SINSW Centre Of Excellence (Richmond)

Road Safety Audit

Detailed Design Stage

JN22024_Report01 Rev01 - TTW Richmond COE

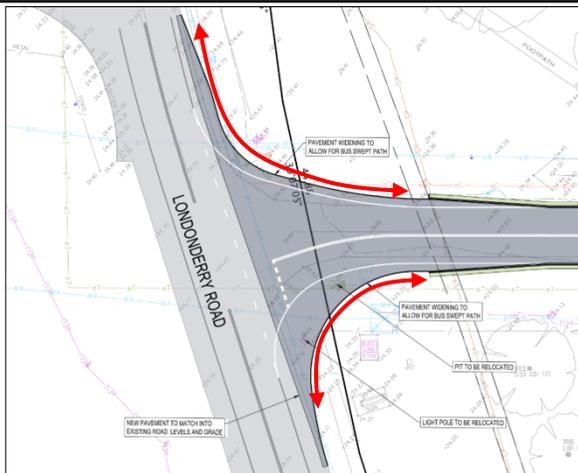
<p>3. Overhanging Branches Extent of Works</p>	<p>There are low and overhanging branches throughout the extent of works.</p> <p>There is a risk that a branch may fall on a vehicle or fall into the travel lane and be impacted by a vehicle resulting in injury to vehicle occupants.</p> <p>There is a risk that a vehicle may impact overhanging branches causing them to fall onto the vehicle or into the travel lane and be impacted by another vehicle resulting in injury to vehicle occupants.</p>	<p>Improbable</p>	<p>Minor</p>	<p>Medium</p>	<p>Height clearances and tree conditions under review with arborist, it is anticipated that pruning will be required to various trees.</p> <p>Some residual overhang of trees is expected as part of the urban design of the space and to retain tree canopy coverage of the area. Ongoing review and maintenance may be required by WSU.</p>
---	---	-------------------	--------------	---------------	---

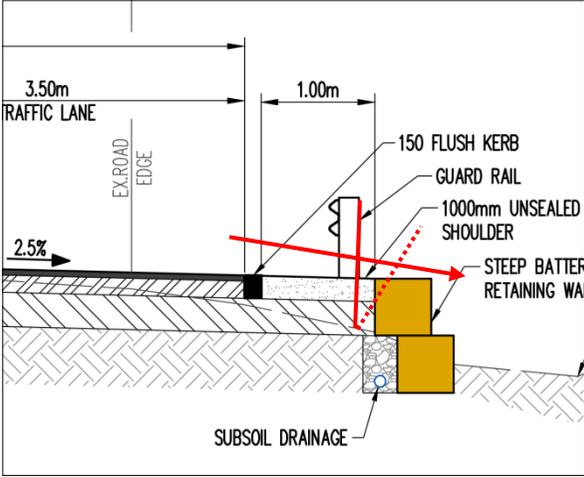
Item Location	Safety Hazard Finding	Frequency	Severity	Level Of Risk	Project Manager Response
<p>4. Barrier Post Support Extent of Works</p>	 <p>There is insufficient support provided behind the barrier post. There is a risk that an errant vehicle may not be contained by the barrier resulting in a vehicle reaching a hazard, snag/roll incidents and injury to occupants.</p> 	<p>Improbable</p>	<p>Serious</p>	<p>Medium</p>	<p>Road sections will be designed to provide the required support distance behind guard rails; design to manufacturer requirements once a barrier product is selected.</p>

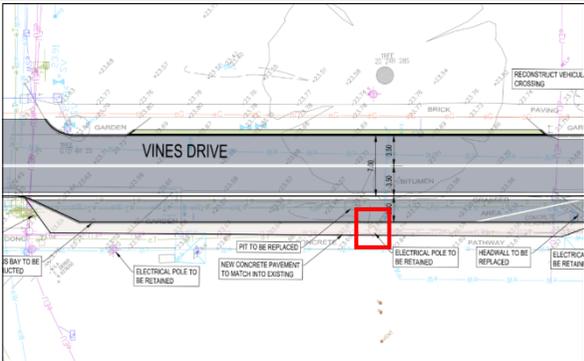
<p>11. Pedestrian Crossing Proximity Extent of Works</p>	<p>There are pedestrian crossings proposed adjacent to intersection points throughout the extent of works.</p> <p>There is a risk that a motorist exiting the intersection may focus on vehicles approaching from the right and not sight a pedestrian entering the crossing from the left resulting in pedestrian-vehicle collisions.</p> <p>This risk is increased given an inconsistent application of pedestrian crossing infrastructure such as approach signage from all directions, line marking, and raised thresholds.</p> <p>This risk is increased where vehicle and pedestrian volumes are increasing.</p>	Occasional	Serious	High	<p>Distance from intersections/driveways to be increased where possible, or pedestrian crossings to be deleted if demand is low to avoid confusion.</p>
---	--	------------	---------	------	---

12.
 Pedestrian Crossing
 Sight
 Extent of Works

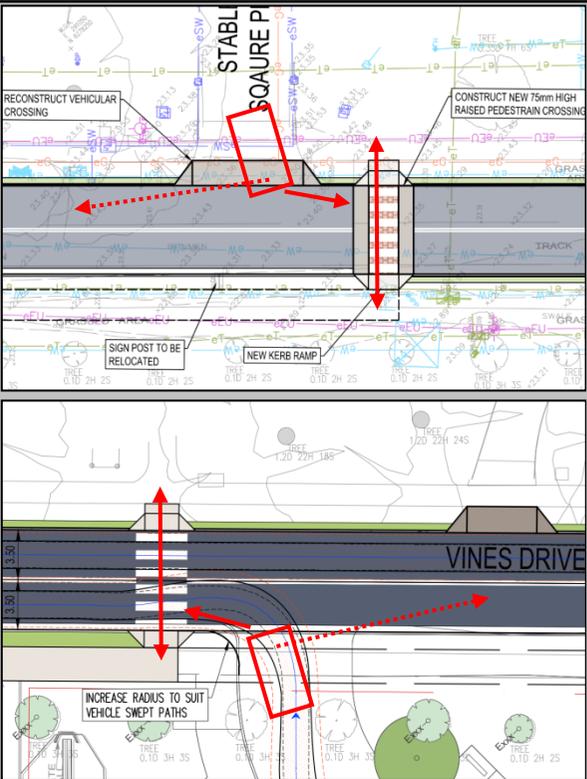
There are multiple pedestrian crossings, both existing and proposed, without line marking, signage and lighting.

The legal requirement for a motorist to give-way at a pedestrian crossing that is not line marked and only sign posted in one direction is not clear.

An inconsistent approach to pedestrian facilities may increase driver confusion/frustration, and decrease pedestrian compliance.

There is a risk that an approaching motorist may not anticipate a pedestrian stepping out into the travel lane resulting in pedestrian-vehicle collisions.

Consistency of crossing treatments is under review. Any crossings in the final design will have line marking and signage in both directions.

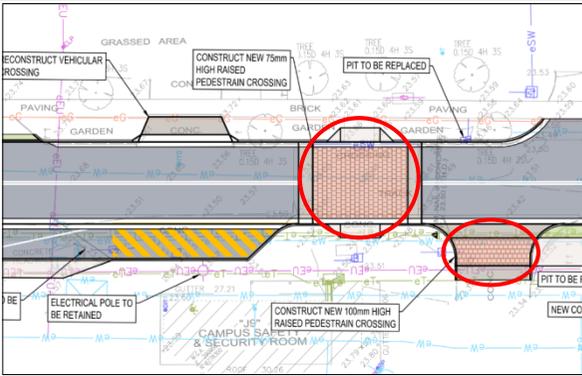
<p>13. Signage Extent of Works</p>	<p>There is insufficient signage provided throughout the extent of works including roundabouts (no stopping, give way), pedestrian crossings, bus stop/contractor parking restrictions, DO-PU parking restrictions.</p> <p>There is a risk that a motorist may park/stop in a location that restricts through vehicles or pedestrian paths resulting in side-swipe collisions or pedestrian-vehicle collisions.</p> <p>There is a risk that a motorist may not sight approaching intersections, configurations, hazards due to parked vehicles resulting in run-off-road, side-impact or side swipe collisions.</p>	Probable	Minor	High	<p>Kerbside parking signage to be provided to all areas. Bus restrictions will be nominated. No Stopping restrictions at the roundabout and other relevant locations will be nominated.</p>
---	---	----------	-------	------	---

14.
 Lighting
 Roundabout

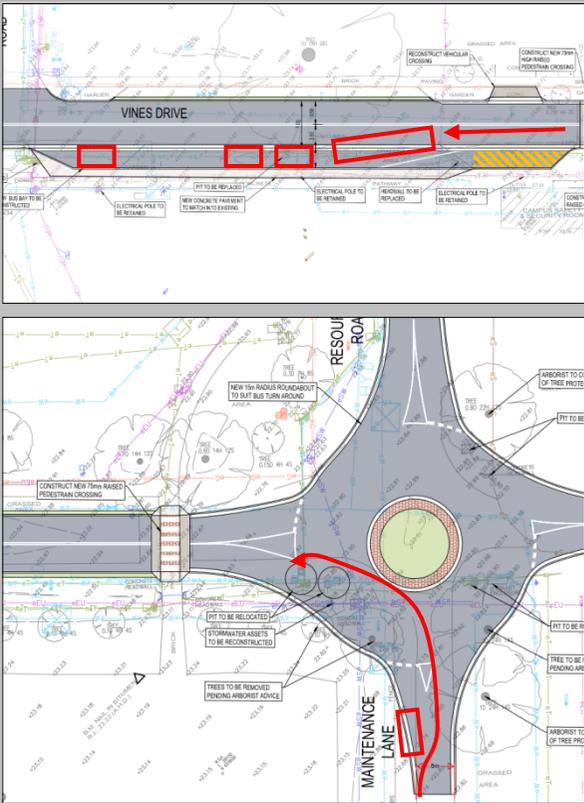
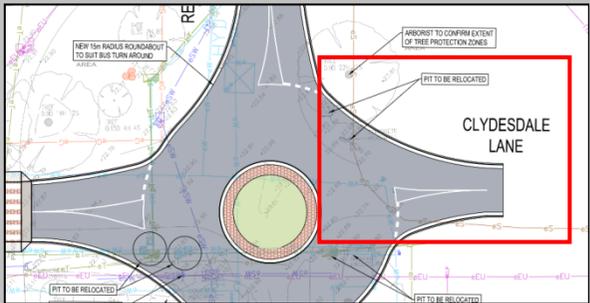
There is no proposed lighting at the proposed roundabout. At the existing curve there is an existing flood light on a pole set back in a paddock that is directed into an eastbound driver's eyes.

There is a risk at night or during adverse weather that a motorist may not sight the intersection configuration resulting in impacts with roadside infrastructure, pedestrians, or other vehicles circulating the roundabout.

Lighting anticipated to be provided at roundabout and pedestrian crossing locations, to be reviewed and confirmed by lighting/electrical consultant.

17.
Width
Maintenance Lane

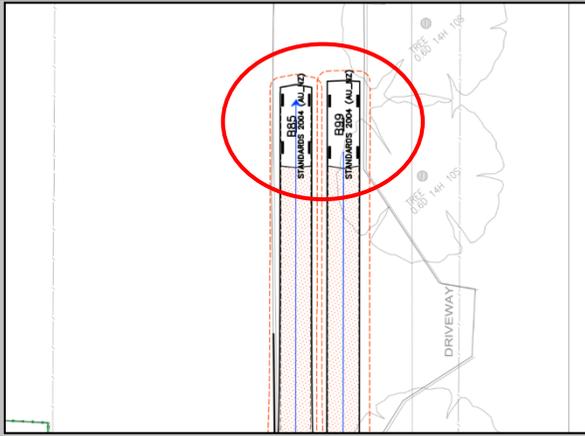
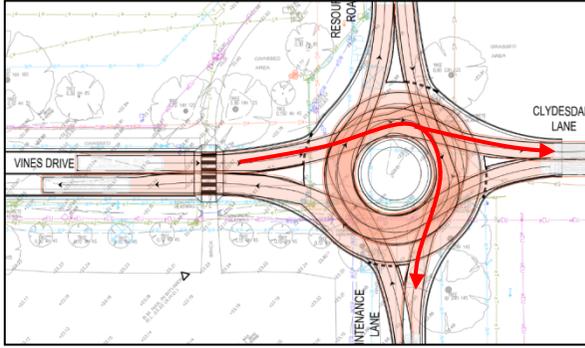
The turning path plan for the roundabout shows 2-way traffic colliding at the Maintenance Lane splitter island, however the Maintenance Lane Carpark turning path plan indicates there is sufficient width for 2-way traffic.

There is a risk that the existing width on Maintenance Lane may not be sufficient for 2-way traffic resulting in side-swipe or head-on collisions with oncoming traffic, run-off-road incidents, or collisions with roadside infrastructure, hazards or pedestrians.

Treatment for two-way traffic along Maintenance Lane is under review. Traffic movements are generally expected to be one-way (e.g. arrivals in the morning, departures in the afternoon) so limited two-way traffic is expected. A priority system can be designed, and will ensure sufficient space for vehicles off the circulating area of the roundabout.

19.
Pedestrian Crossing
DO-PU

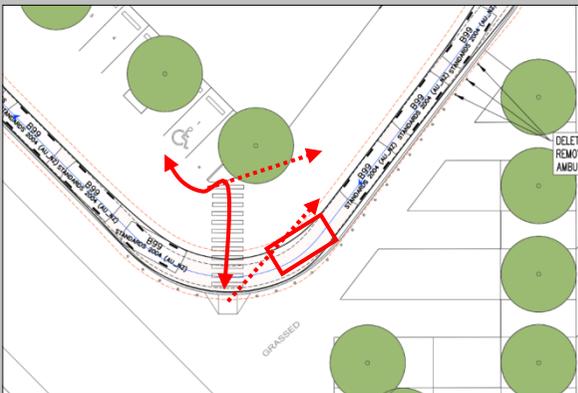
The pedestrian crossing inside the DO-PU area has no lighting, no signage, no kerb ramp on the northern side, a tree blocking sight from the northern side and requires a pedestrian to cross 2 lanes of approaching traffic.

There is a risk that an approaching motorist may not sight a pedestrian stepping out into the travel lane resulting in pedestrian-vehicle collisions.

There is a risk that a parked vehicle may restrict sight between a through vehicle and a pedestrian resulting in pedestrian-vehicle collisions.

Zebra crossing to be deleted to avoid confusion, signage and line marking for PUDO vehicles and tree to be reviewed.

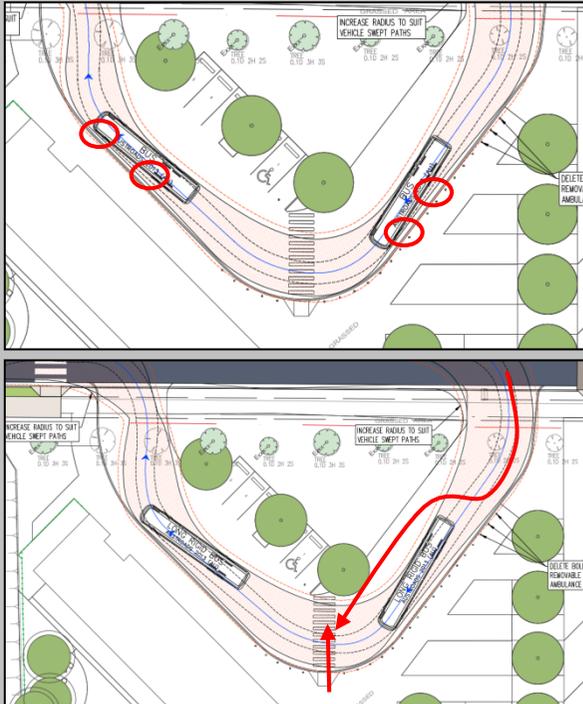
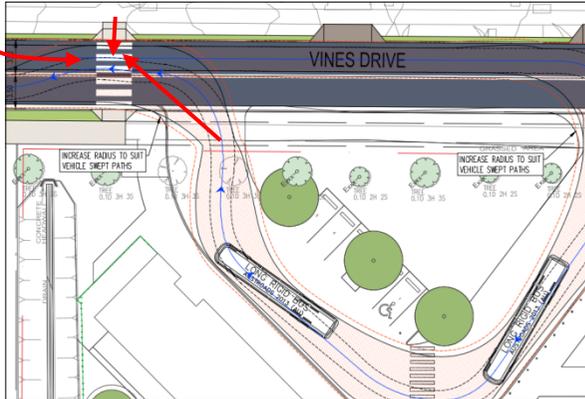
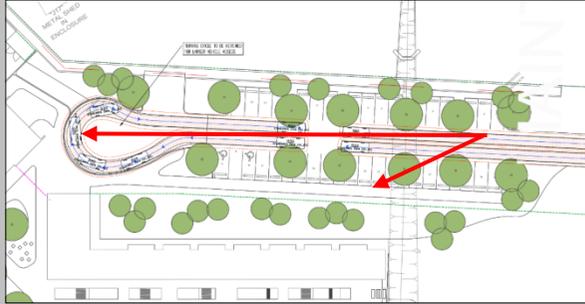
Item Location	Safety Hazard Finding	Frequency	Severity	Level Of Risk	Project Manager Response
<p>21. Large Vehicle Angle DO-PU</p>	<p>The provided turn paths for the large vehicle in the DO-PU facility indicates the vehicle cannot pull up parallel to the kerb, particularly at mid/rear doors.</p> <p>There is a risk that large vehicle may pull up a significant distance from the kerb and require a pedestrian to step across a wide gap or step down onto the road and up to the bus/kerb resulting in trip-fall injuries.</p> <p>There is a risk that a stopped bus may partially block the through lane, encouraging a motorist to travel around the bus in close proximity to a pedestrian crossing, resulting in pedestrian-vehicle collisions.</p>	Probable	Limited	Medium	<p>Acknowledged that some blockages may occur for the largest vehicles. Buses to be encouraged to use Vines Drive bus stop wherever possible. Buses may be required to manoeuvre to be parallel / closer to the kerb.</p>
